**PARISH OF ASCENSION**  
**OFFICE OF PLANNING AND DEVELOPMENT**  
**PLANNING DEPARTMENT**

**Planning Commission**

January 11, 2017 - 6:00 PM

**AGENDA**

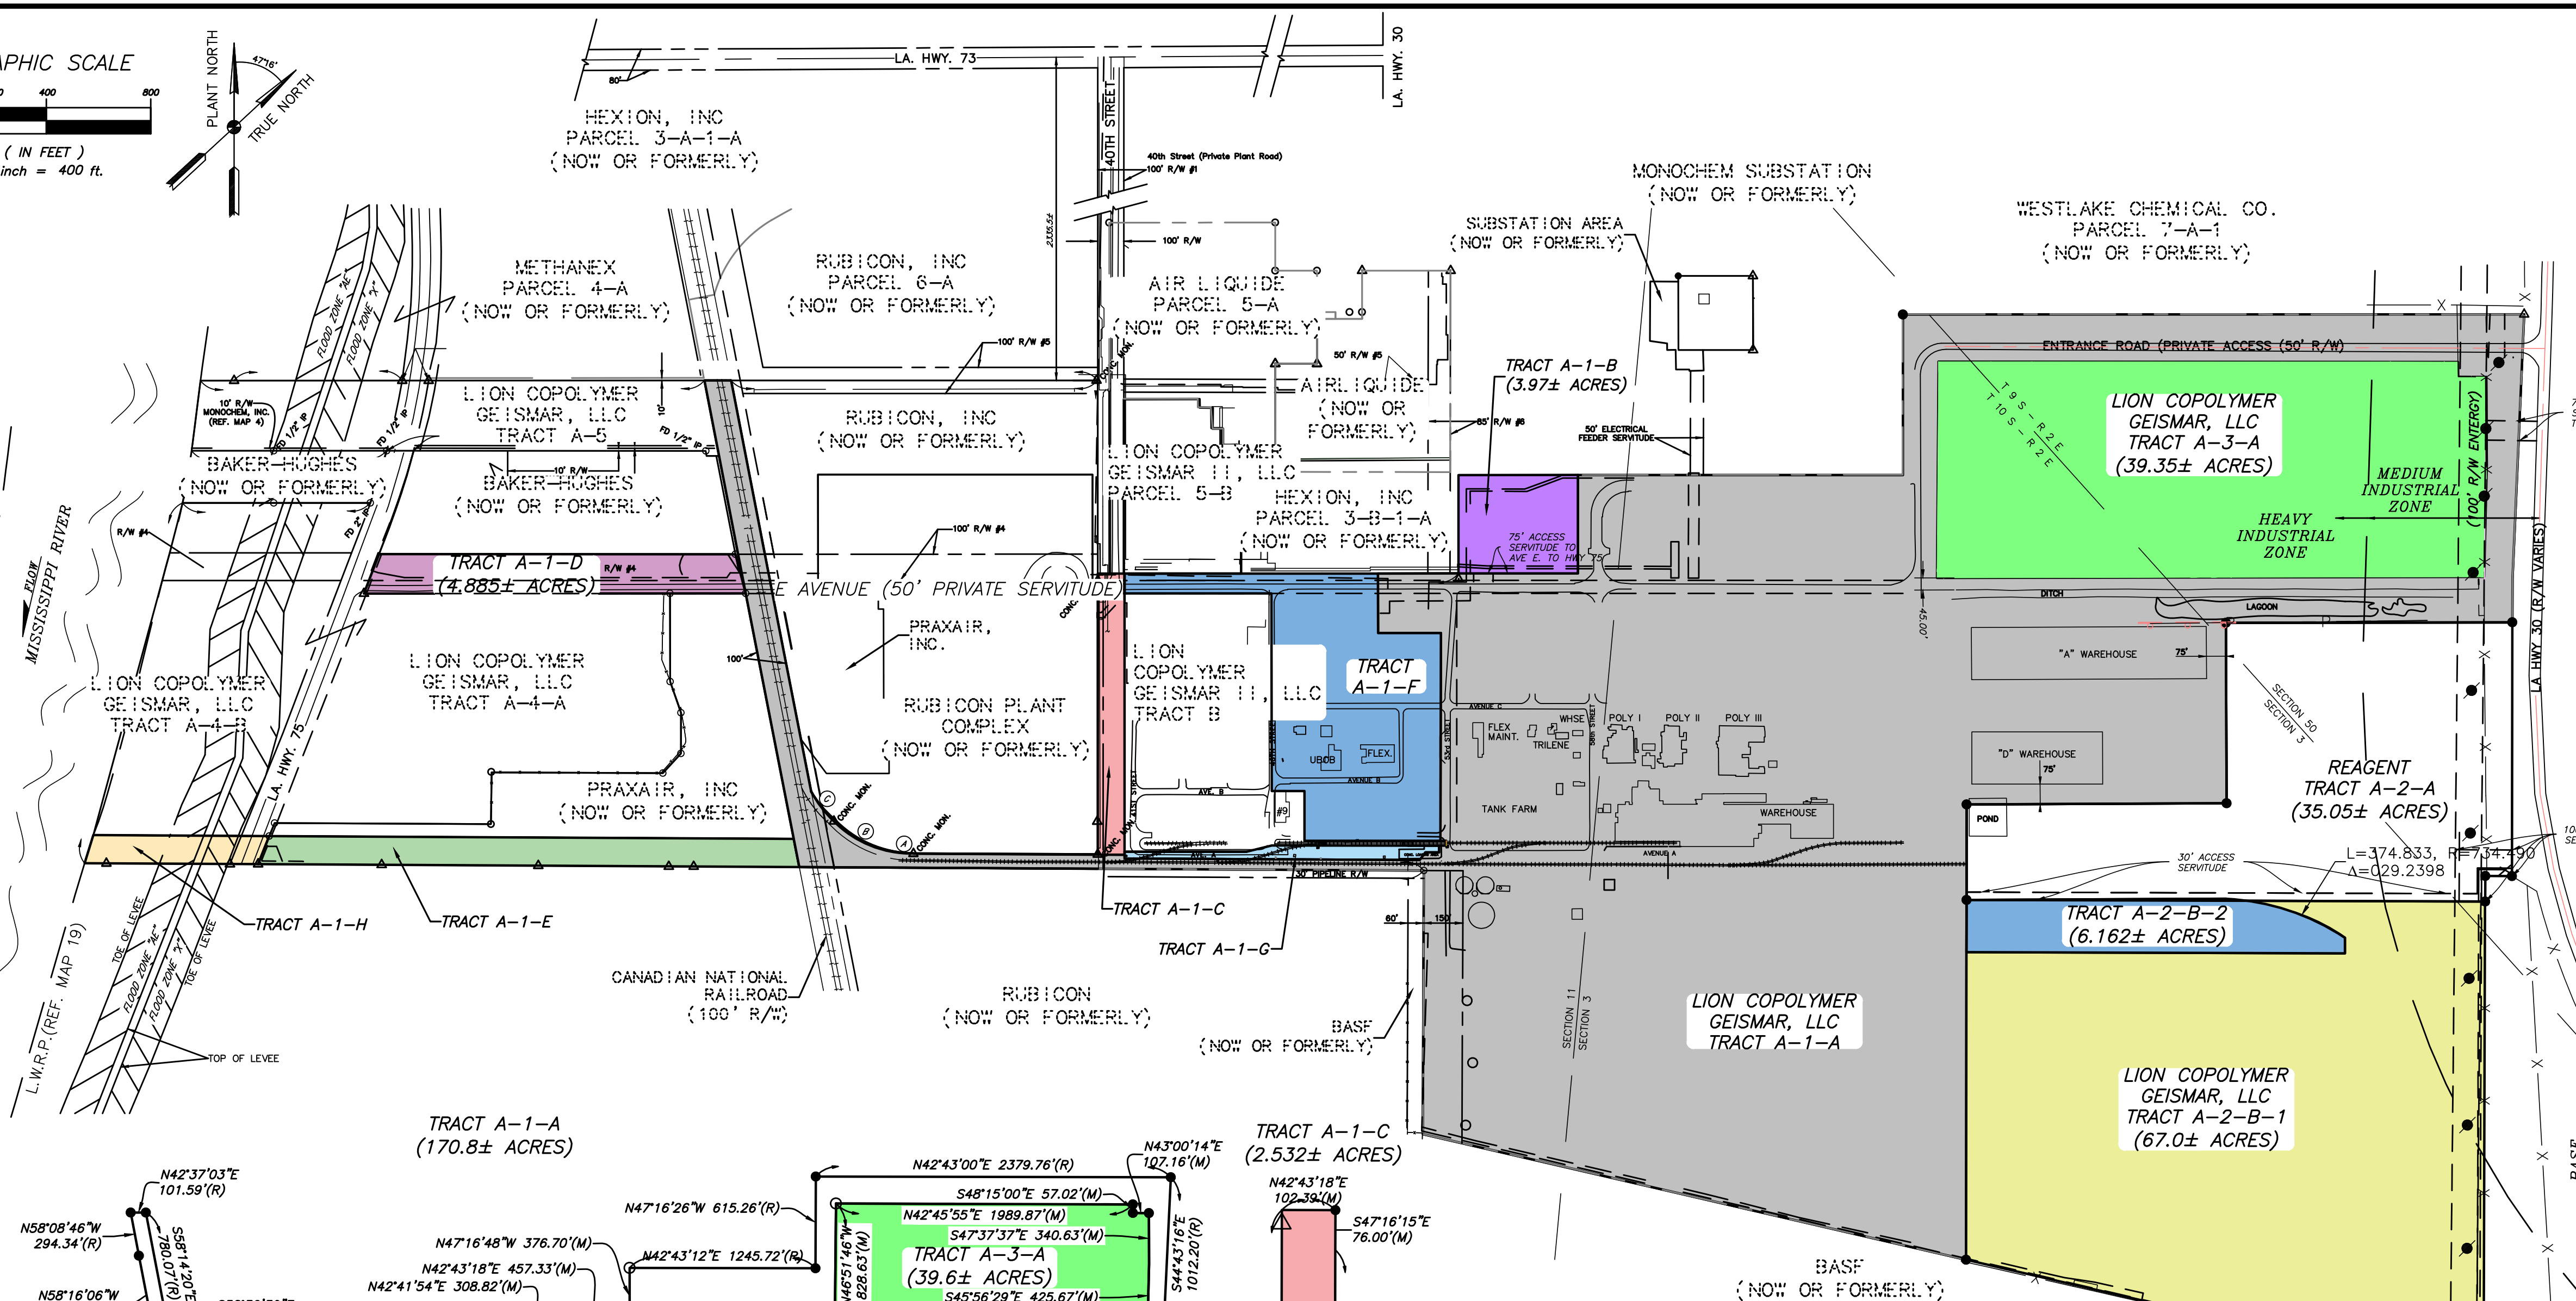
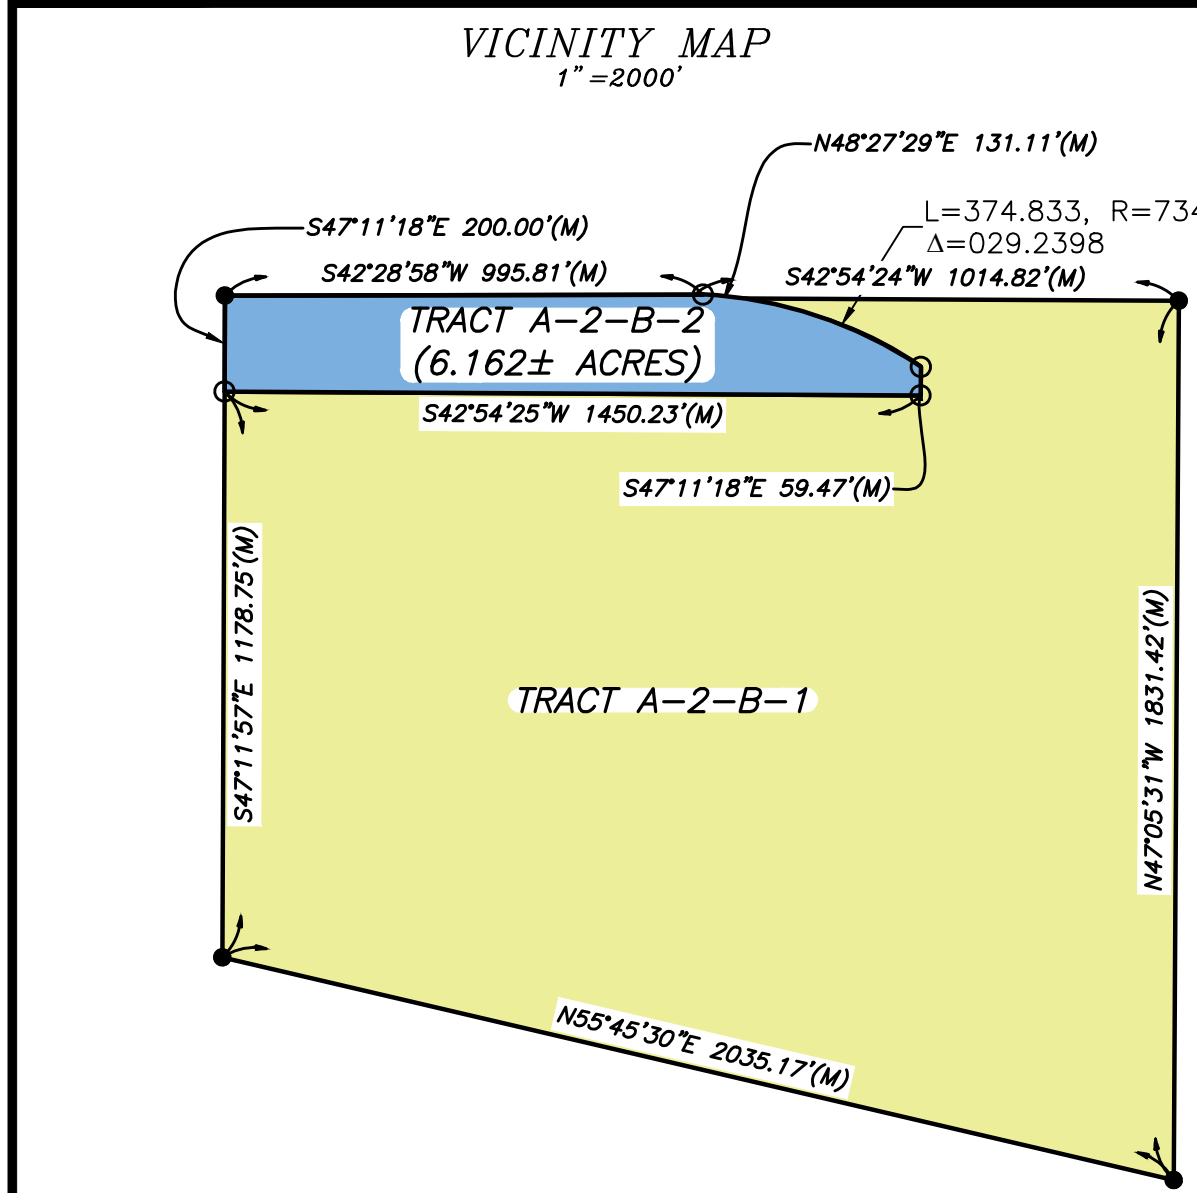
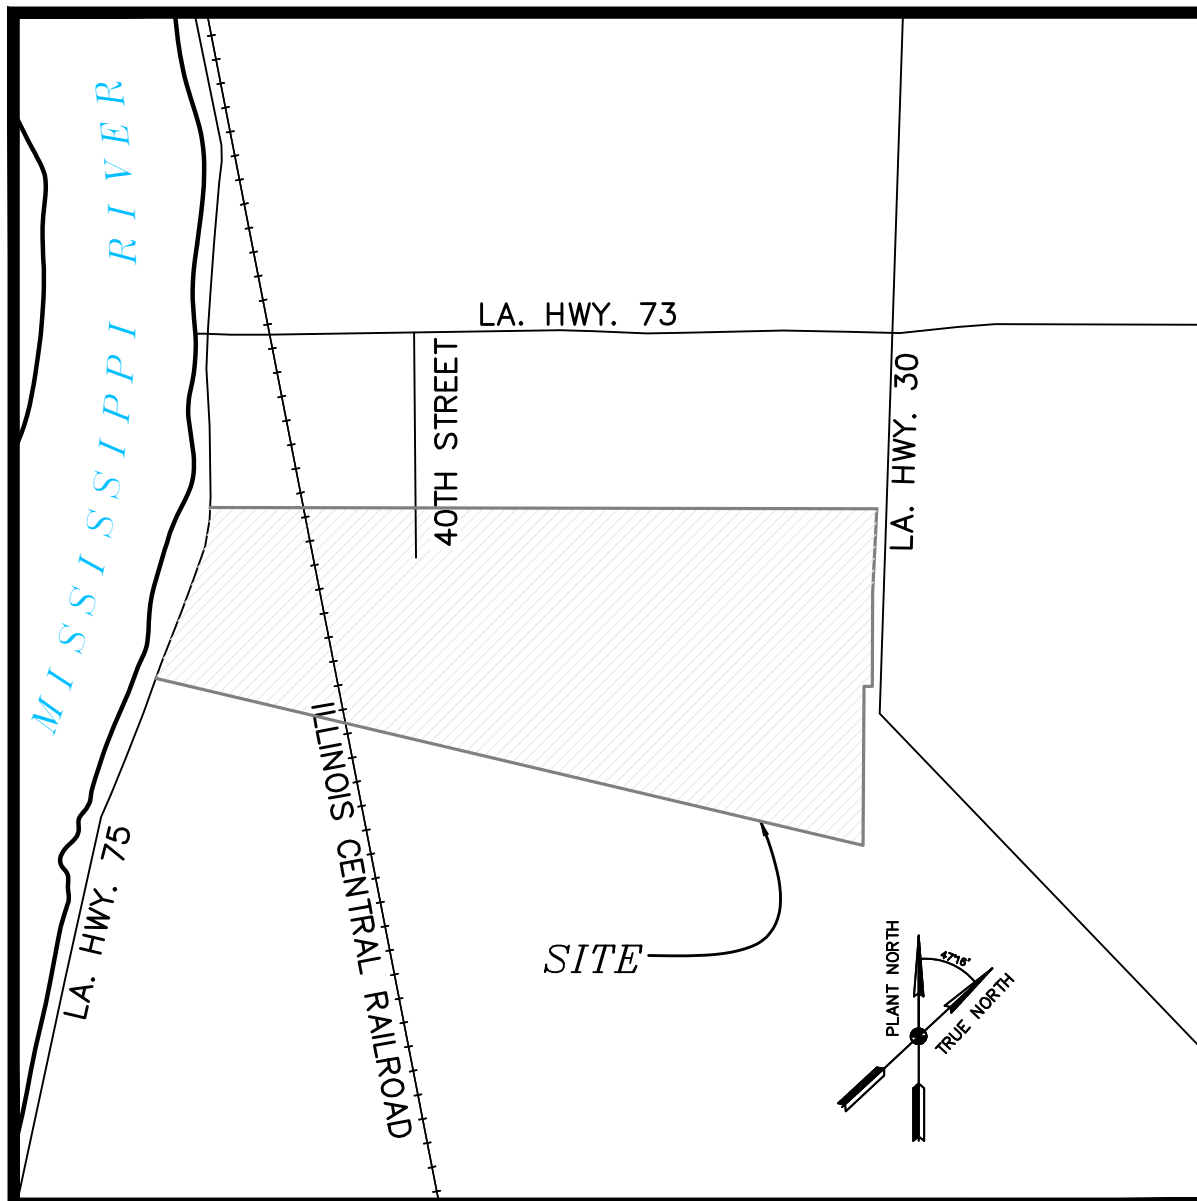
- a) Clearly show all Rights of Way and Access Servitudes on map. **Plat has been corrected.**
- b) Show Instrument No. 798493 for Reference No. 1. **Plat has been corrected.**
- c) Add the Subdivision of Tract A-2 from August 5, 2013 and Instrument No. 832013 as a reference. **Plat has been corrected.**
- d) Add information on Certification under item 'S', Land Surveyor Certification contained on Plat Review Submittal Checklist. **Plat has been corrected.**
- e) Tract A-3-A is not detailed or dimensioned with bearings. **Plat has been corrected.**
- f) Denote block and list "Waiver Requested" – Subdividing Lots Not Upon a Public ROW", on map. **Plat has been corrected.**
